**LATHROP DITCH IMPROVEMENTS
ITB-25-05**

ADDENDUM NO. 1

March 3, 2025

GENERAL NOTES, ABBREVIATIONS,
AND ESTIMATE OF QUANTITIES

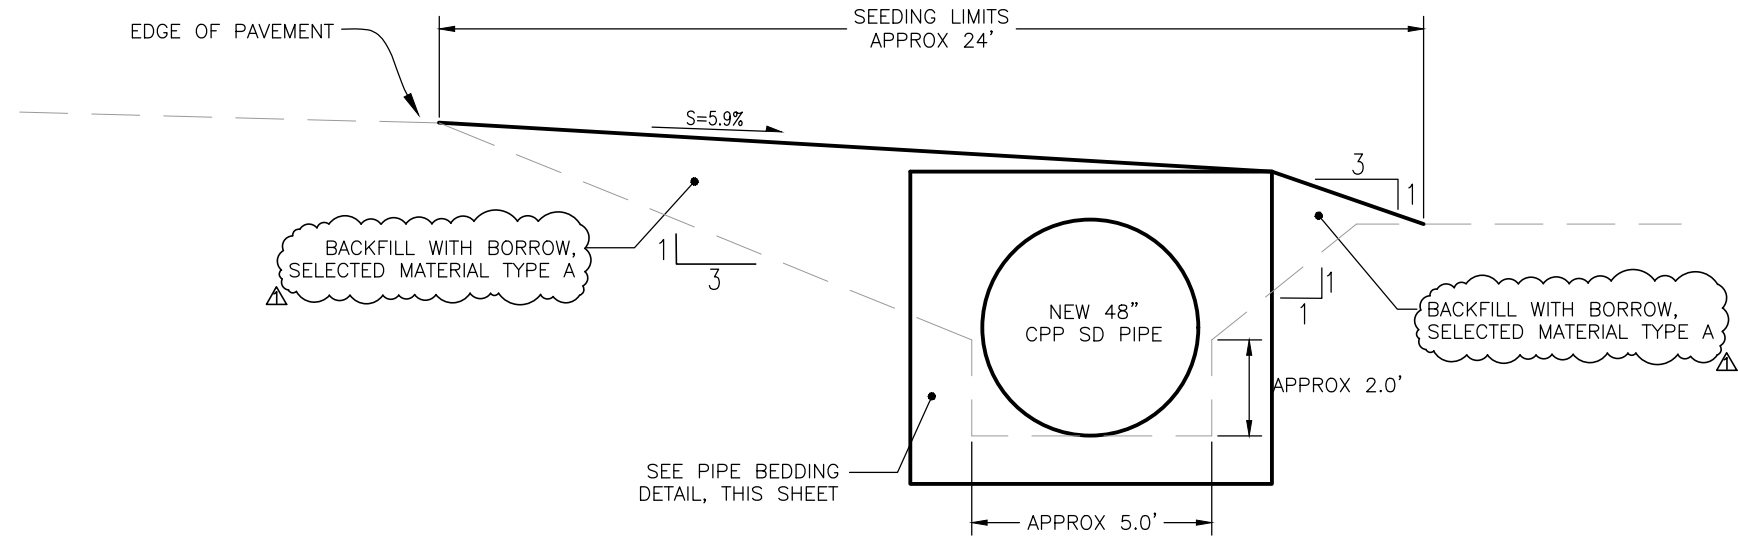
Delete Plan Sheet Nos. A2 and B1 and substitute revised Plan Sheets Nos. A2 and B1.

TYPICAL SECTION

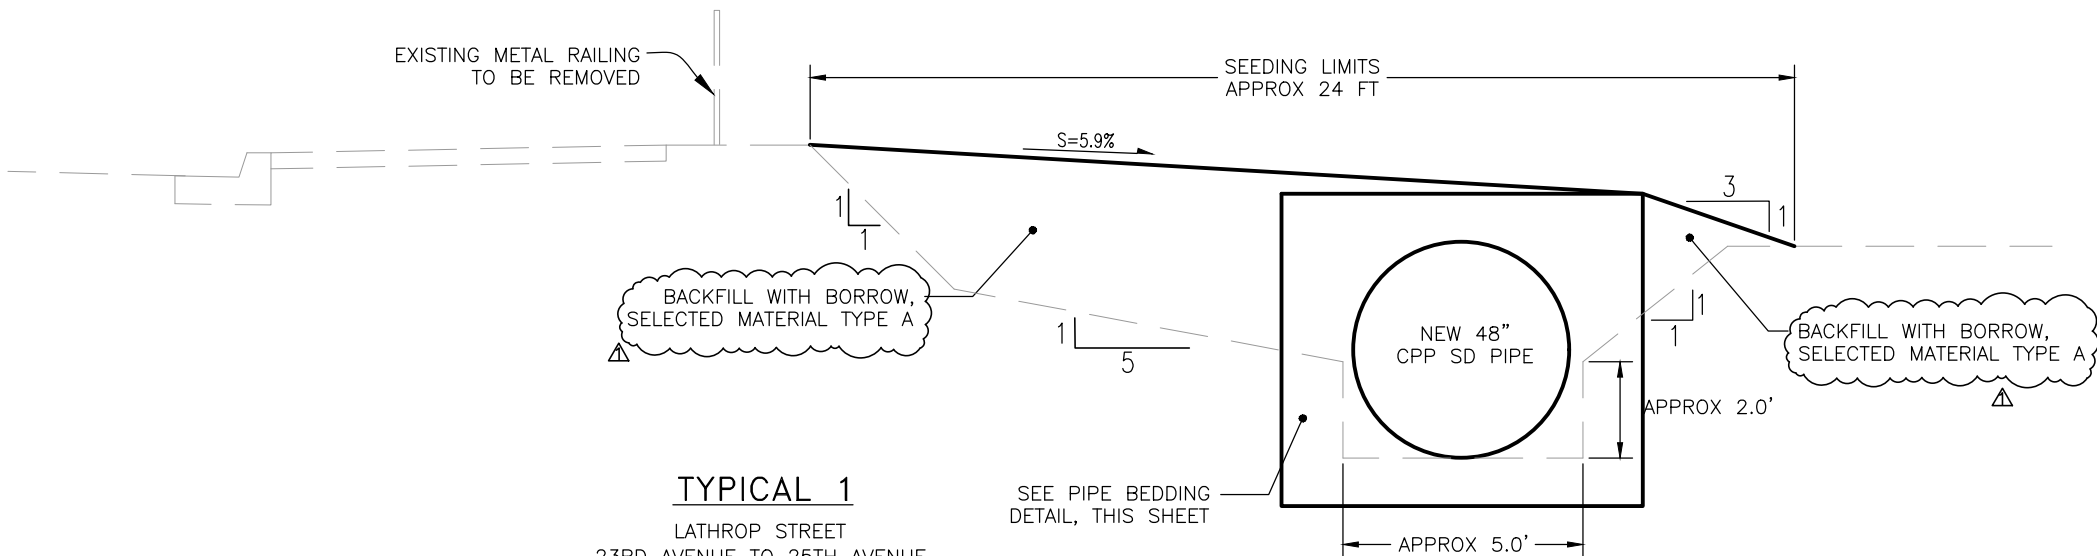
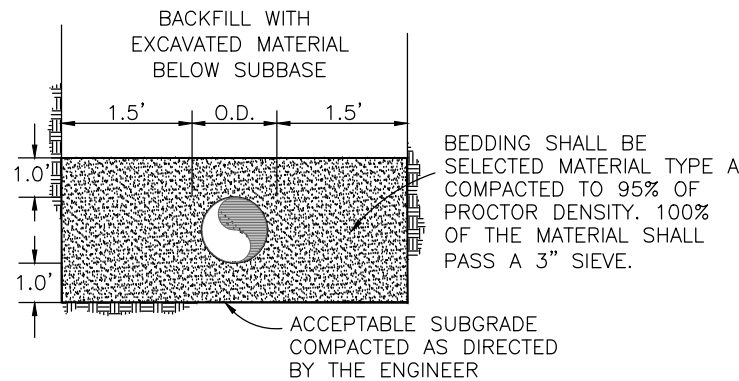
Delete the word "backfill" from the second paragraph.

1. INSTALL NEW CPP PIPE IN EXISTING DITCH FLOWLINE OR AS DIRECTED BY THE ENGINEER.
2. NOTE, THE PIPE BEDDING DETAIL AS SHOWN ON THIS SHEET MODIFIES THE STANDARD PIPE BEDDING DETAIL SHOWN ON SHEET SD1.
3. PIPE BEDDING IS SUBSIDIARY TO THE RESPECTIVE 603 PAY ITEM BEING INSTALLED. BORROW, SELECTED MATERIAL TYPE A USED FOR BACKFILL WILL BE PAID BY THE TON UNDER PAY ITEM 203.0006.0000
